Delegated Report

Householder Planning Application

Planning Application No: 20230338

Description: Expansion of existing first floor balcony at the rear of the property with installation of spiral staircase with cast iron balustrades.

Existing & Proposed Rear Elevations

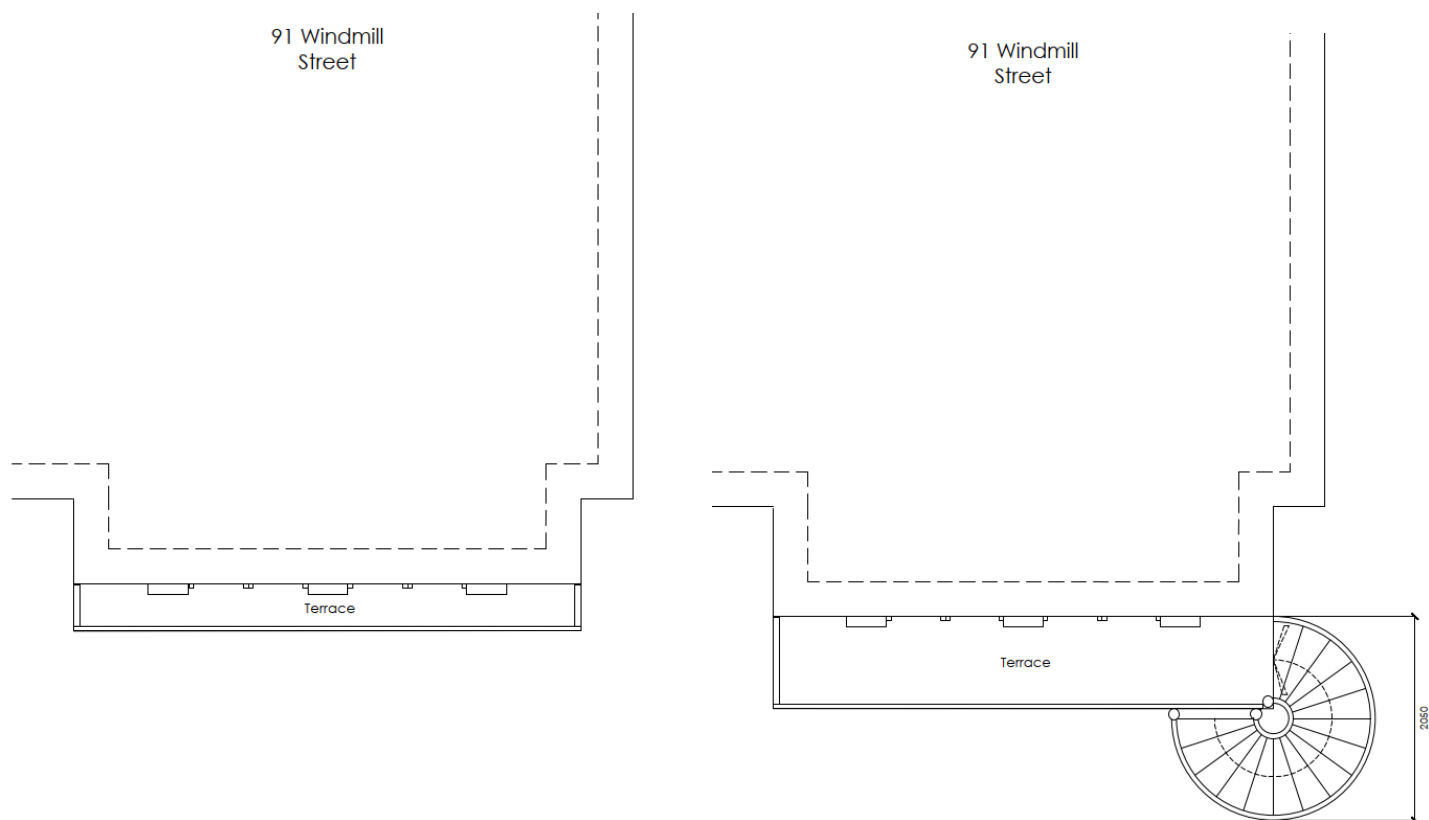
The existing balcony extends across the first floor bay window on the rear elevation. The proposal is to enlarge this balcony and construct a staircase to provide access down to garden level. The existing balcony is 10.1m, 0.96m in depth and 1.32m in height. The proposed balcony would be the same width, 1.8m in depth and 2.3m in height with decorative railings in a different design to the existing. The spiral staircase to the side would have the same decorative railing design. Overall the balcony and staircase is well designed and would respect the character and appearance of the dwelling. Due to the location of the development at the rear of the dwelling there would be no impact on the Windmill Hill Conservation Area and its character and appearance would therefore be preserved. However, as stated the decorative railings are considered of good design and they would be in made of cast iron. In respect of design, character, appearance and heritage the proposal is therefore considered compliant with Policies CS19 and CS20 (LPCS) and saved Policy TC3 (LPFR).

As stated, the existing balcony is 10.1m in width, 0.96m in depth and 1.32m in height. The proposed balcony would be the same width as existing, 1.8m in depth and 2.3m in height with decorative railings surrounding the balcony. The spiral staircase would be attached to the side and provide access down to the garden. The proposed balcony would be 840mm greater in depth. The existing and proposed balconies are as follows:

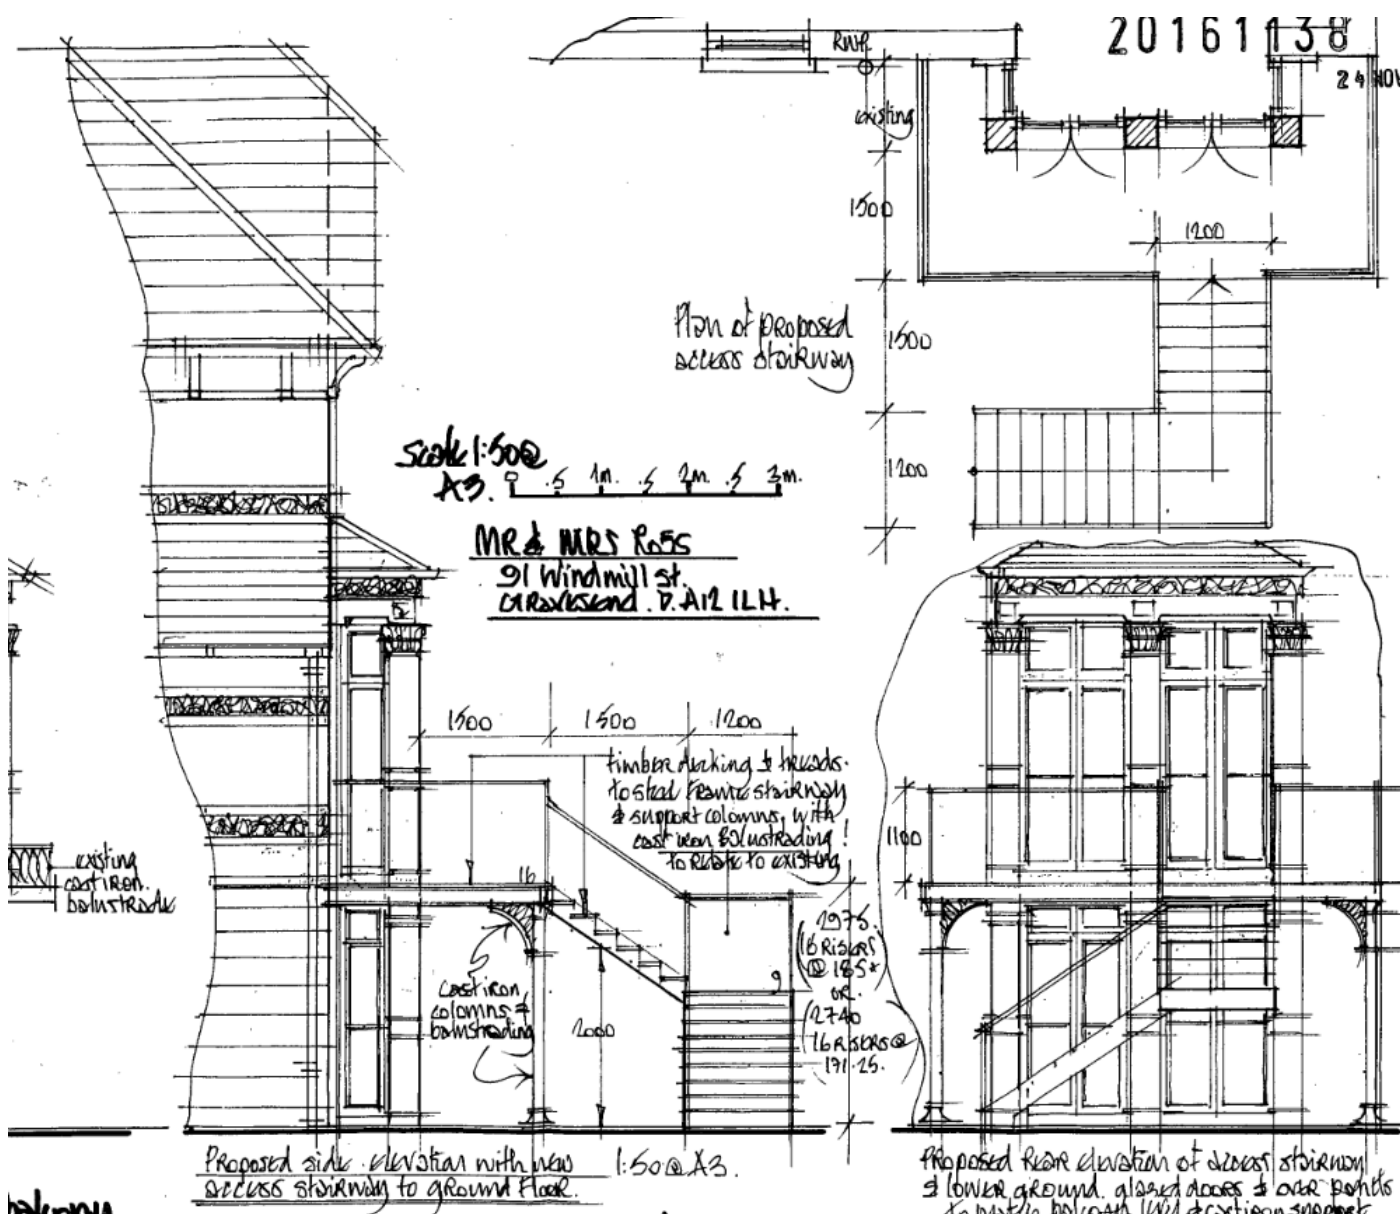
There are two neighbouring properties, no. 90 to the south and no. 92 to the north. The layout of these properties is shown below:

No. 90 Windmill Street is set further forward than the application property (by some 9.3m). There would therefore be no opportunity for any overlooking of any windows in no. 90 or the private garden area (first 5m from rear elevation of dwelling). Therefore, due to this the proposed enlarged balcony would not have impact on the amenity of no. 90 in respect of any overlooking.

No. 92 Windmill Street is set further back from the application property (by some 7m). Again due to no. 92 being set much further back there would also not be the opportunity of any overlooking any windows or the private garden area over and above what can currently take place from the existing balcony. As such it is considered there would be no material harm caused to the amenity of occupiers of no. 92.
